DOVER PLANNING BOARD – AGENDA

PLANNING BOARD - STAFF MEMO FILE # WAIV-2024-0003

Application Type: Site Plan Review
Applicant(s): Dover Housing Authority
Owner(s): Dover Housing Authority
Location: 48 Whittier Street (Tax Map 33, Lot 1-A)
Meeting Date: April 9, 2024

Subject: TDR Site Plan Amendment Application
Planning Board Application
Dover Housing Authority
48 Whittier St
Tax Map 33, Lot 1-A
Dover File #P21-37
WAIV-2024-0003

UTILITY PLAN & PROFILE
LAND OF
OVER HOUSING AUTHORITY
48 WHITTIER STREET
DOVER, N.H.
TAX MAP 33, LOT 1-A

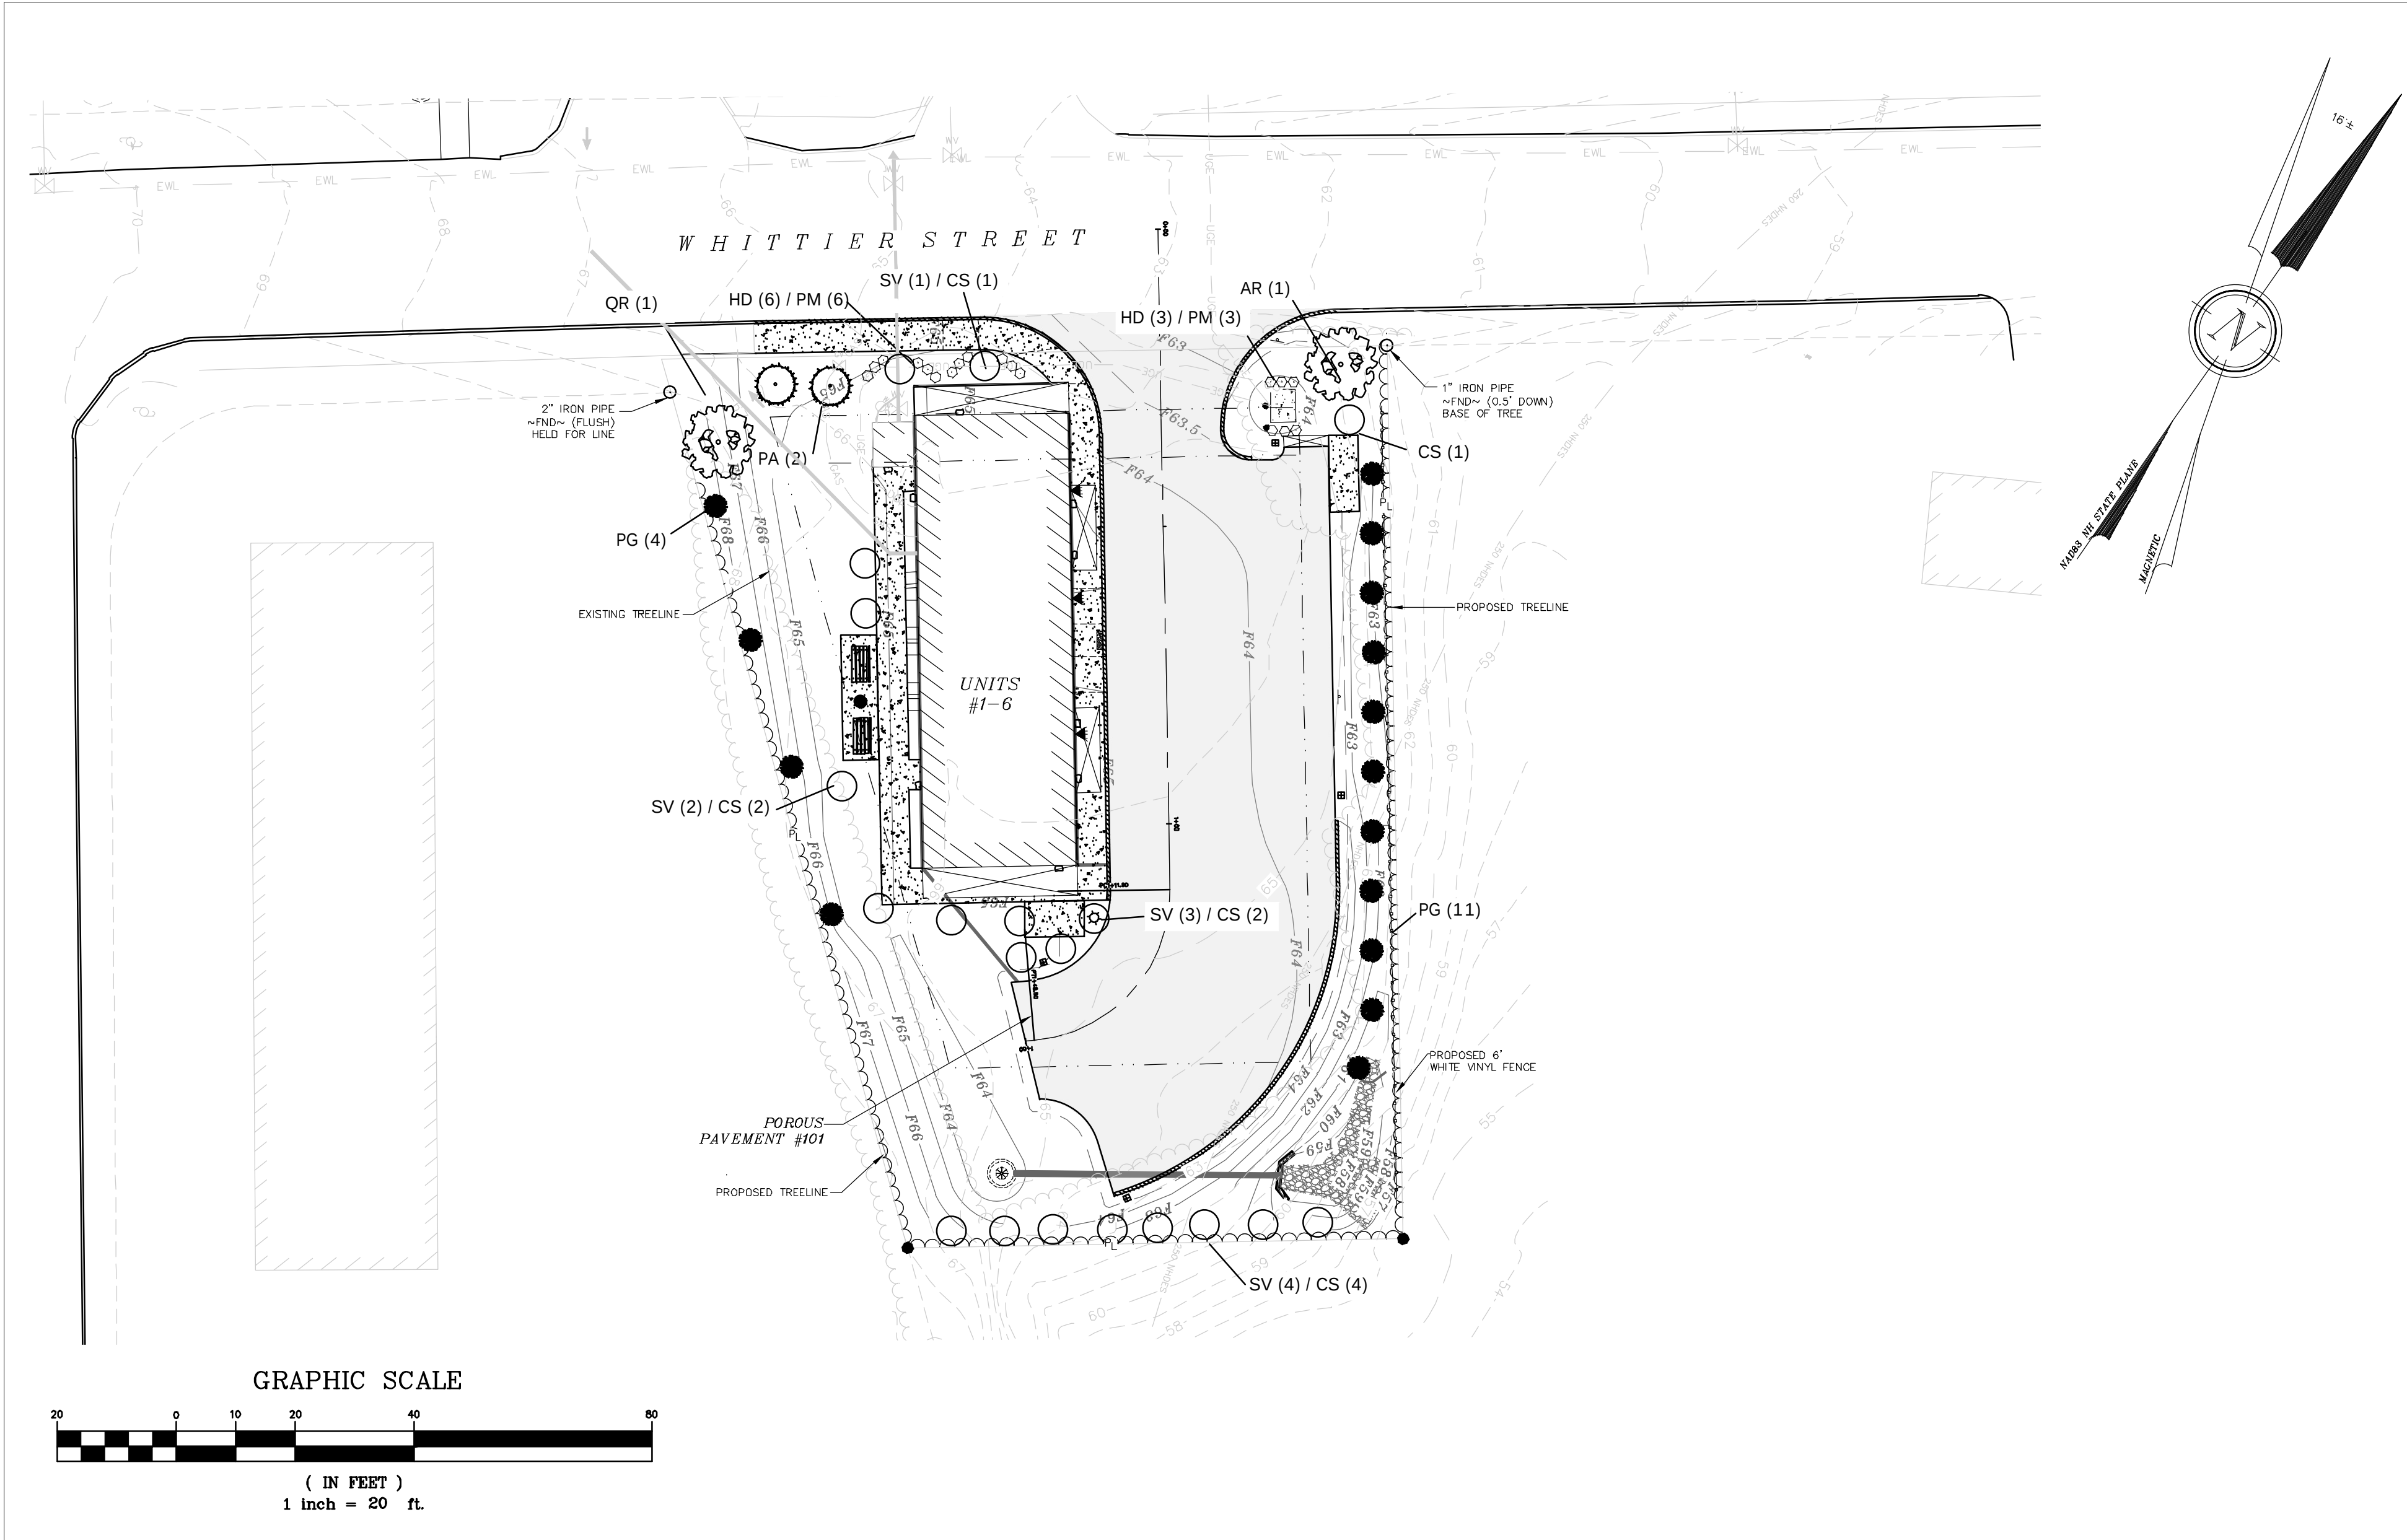
Comments: Sheet 8 utility plan indicates the gas line and 6 gas meters near water meter doghouse. Gas meter location appears to be within prohibited zone from building openings. See SD-06-clarify.
 Sheet 8 Electrical service and 7 meters do not appear to have enough wall space for mounting with window and gas meter locations See elevation SD-06 - clarify.
 Building elevation plans to include utility equipment.
 Sheet 8 utility plan indicates the gas line and 6 gas meters near water meter doghouse. Gas meter location appears to be within prohibited zone from building openings. See SD-06-clarify.
 Sheet 8 Electrical service and 7 meters do not appear to have enough wall space for mounting with window and gas meter locations See elevation SD-06 - clarify.
 Building elevation plans to include utility equipment.

1. It would be helpful to see an overlay with the proposed changes highlighted in red.
Please find provided overlay plan as part of the submission.
2. Engineering recommends tying into the water and gas closer to southern end of the building to avoid trenching through the porous pavement.
Please find revised Utility Plan, sheet #8.

The doghouse location has been revised to the front of the building. Utilities have been revised accordingly. Please find sheets #4 & #8.

SHEET 10 OF 21

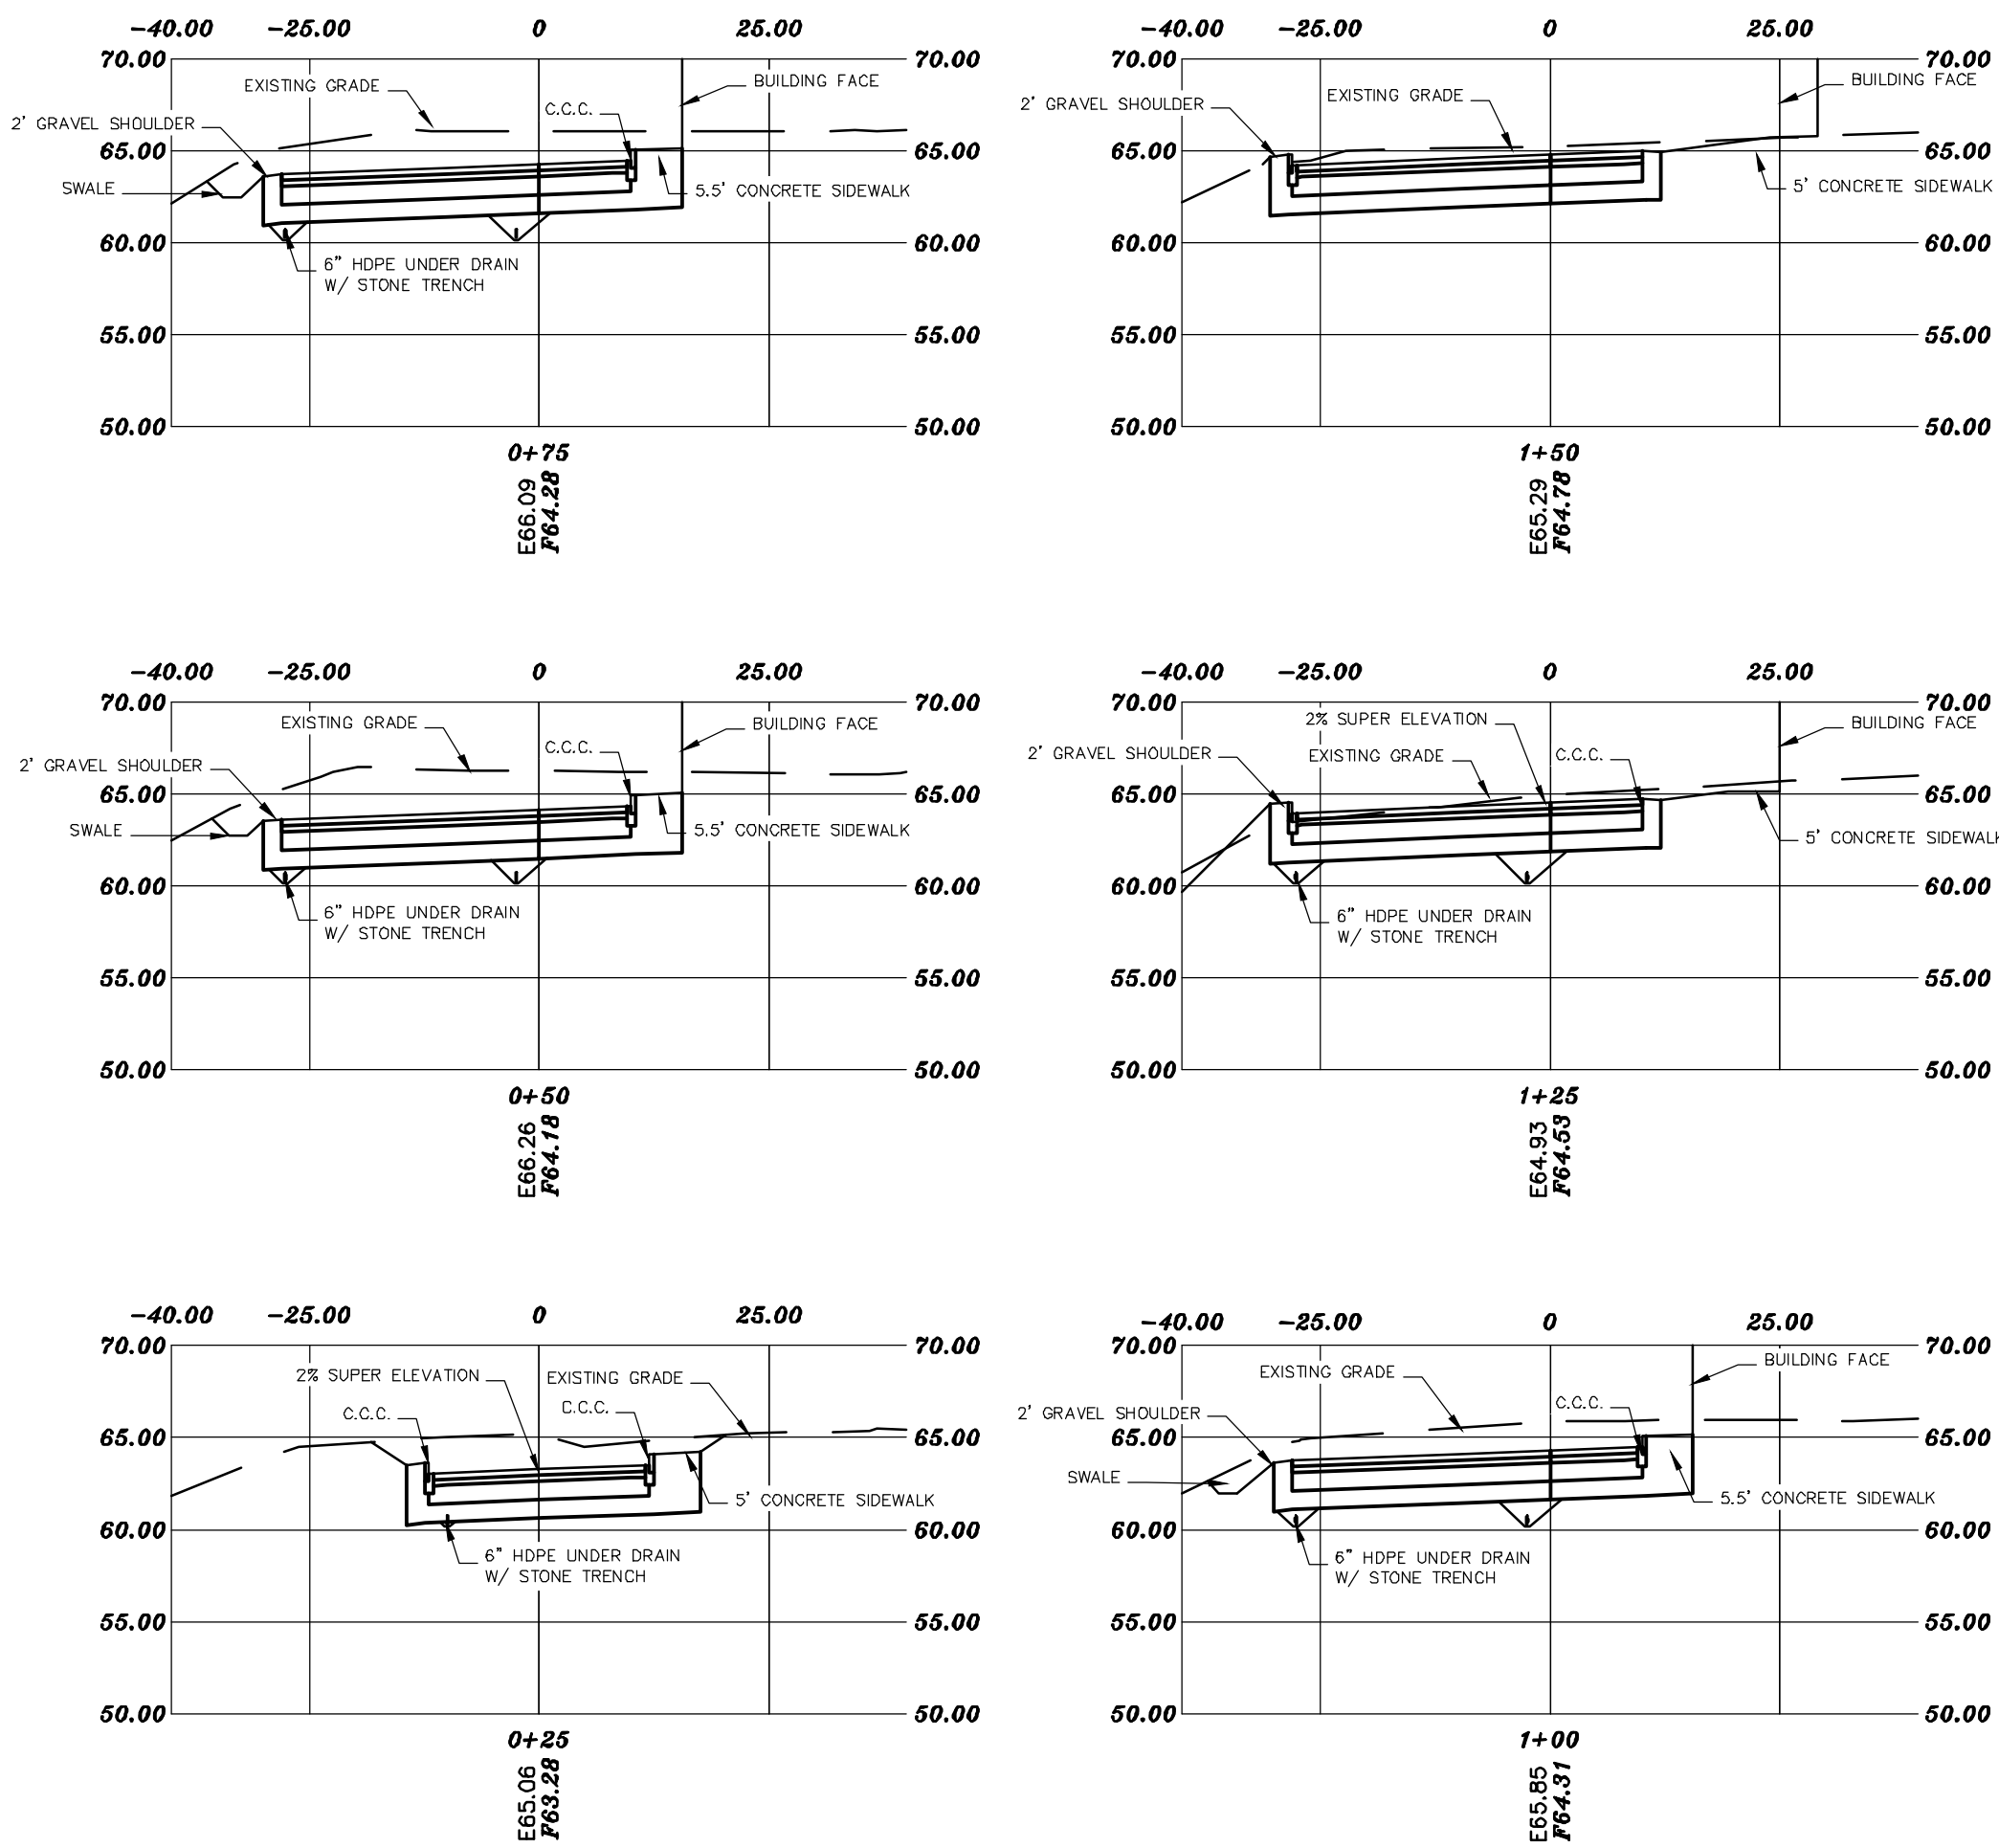
- Address light spill over onto adjacent lots.
Please find revised Lighting Plan, sheet #10.
 - Add sidewalk on easterly side.
A sidewalk is unable to be placed on the easterly side of the parking lot due to grading/drainage considerations. The uncurbed area between the bike rack and the curbing at station 1+00 is needed to allow for runoff to sheet into a conveyance swale and level spreader in a controlled manner if the porous pavement was to fail.

Please find revised Lighting Plan, sheet #10.
